## Appendix TNA2 – 2012 Hydraulic Modelling Report

# **Weston Villages Strategic Flood Solution**

## **River Banwell Modelling Report**

Revised Final Report

Figure 9.6: Flood extents for 1 in 100 year event; left: baseline, right; post development

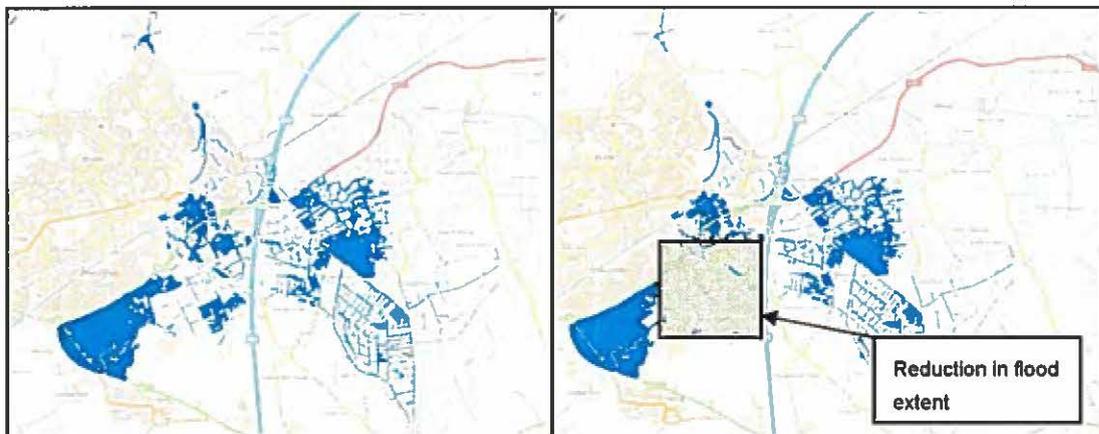
Page 60 - Flood Extent - 'Post Development there is significant reduction in the flood extents East of the MS near west wicks.
